Harrison, Town-Village Recreation Center Phase 2  
270 Harrison Avenue  
Harrison, NY 10528

RFI 051 - Clarifications  
at Corridor 114 &  
Fitness Rm123

#### Corridor 114

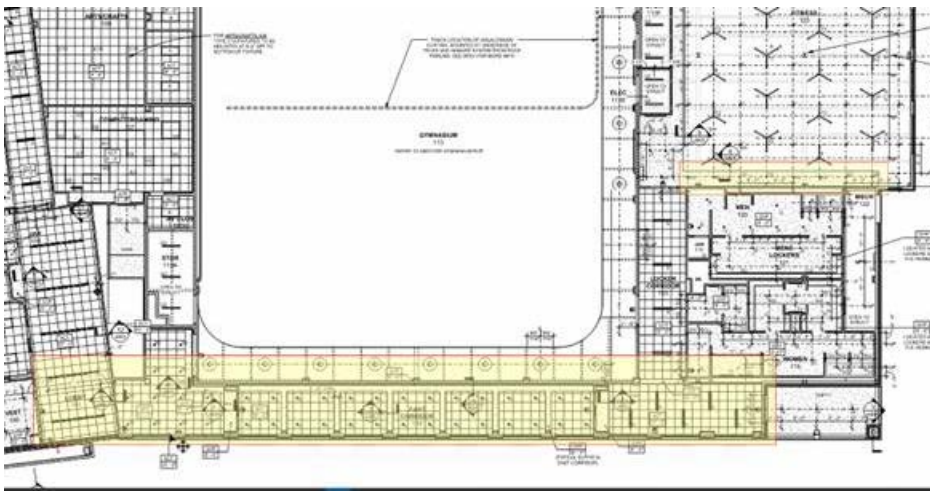
- *Corridor 114: Please confirm if the ceiling should be lowered from 10’ to 9’. The lights interfere with the duct, and the ductwork also interferes with the ceiling.*
  - *Fitness Room 123: Please confirm if the soffit should be increased in size by approximately 2’. The lights interfere with the duct, and the ductwork also interferes with the sprinkler.*
- Let me know if you need any further adjustments.*

Shift supply air duct plan north to avoid lights. Adjust location of supply tap to diffuser as necessary. Shift transfer duct plan south and locate transfer duct on top of supply air duct between beams.

See above for Mechanical response. Similar to Fitness 123 the light fixture transformer can be located to the side of the fixture.

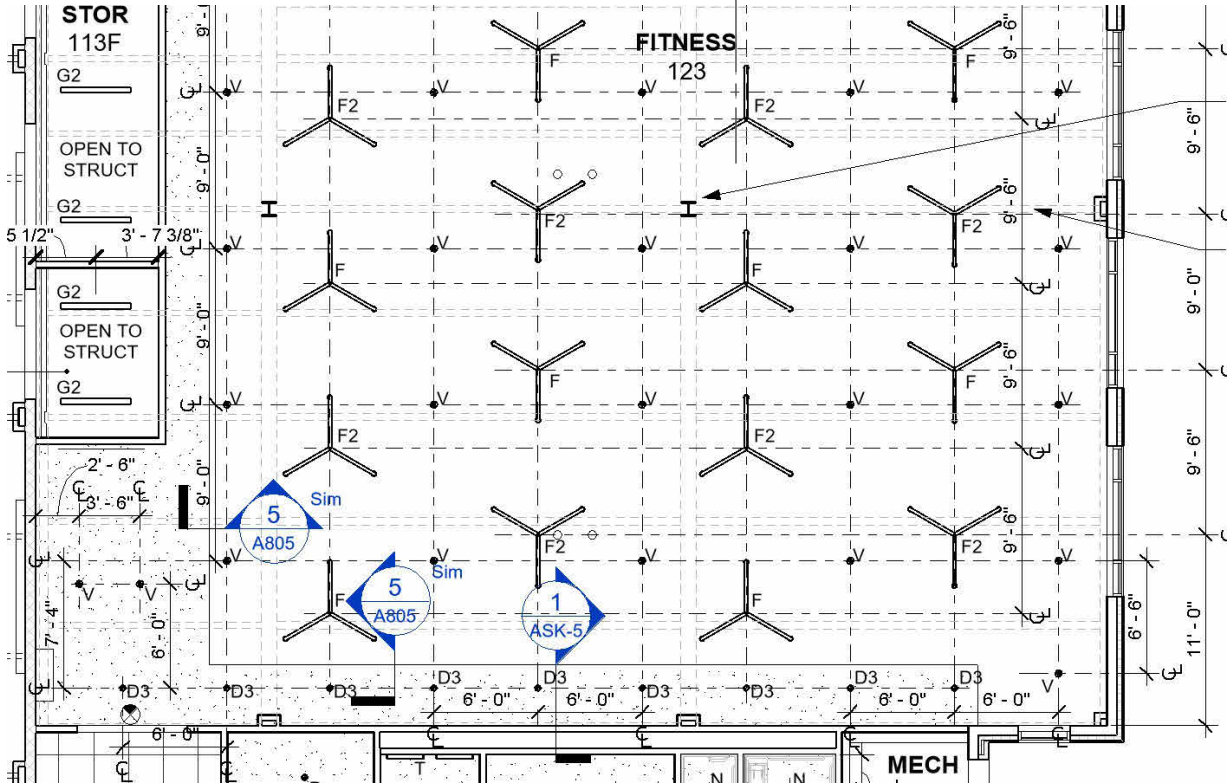
Per today's coordination meeting, we need the following clarifications at the highlighted locations:

- **Corridor 114:** Please confirm if the ceiling should be lowered from 10' to 9'. The lights interfere with the duct, and the ductwork also interferes with the ceiling.
- **Fitness Room 123:** Please confirm if the soffit should be increased in size by approximately 2'.

The lights interfere with the duct, and the ductwork also interferes with the sprinkler.
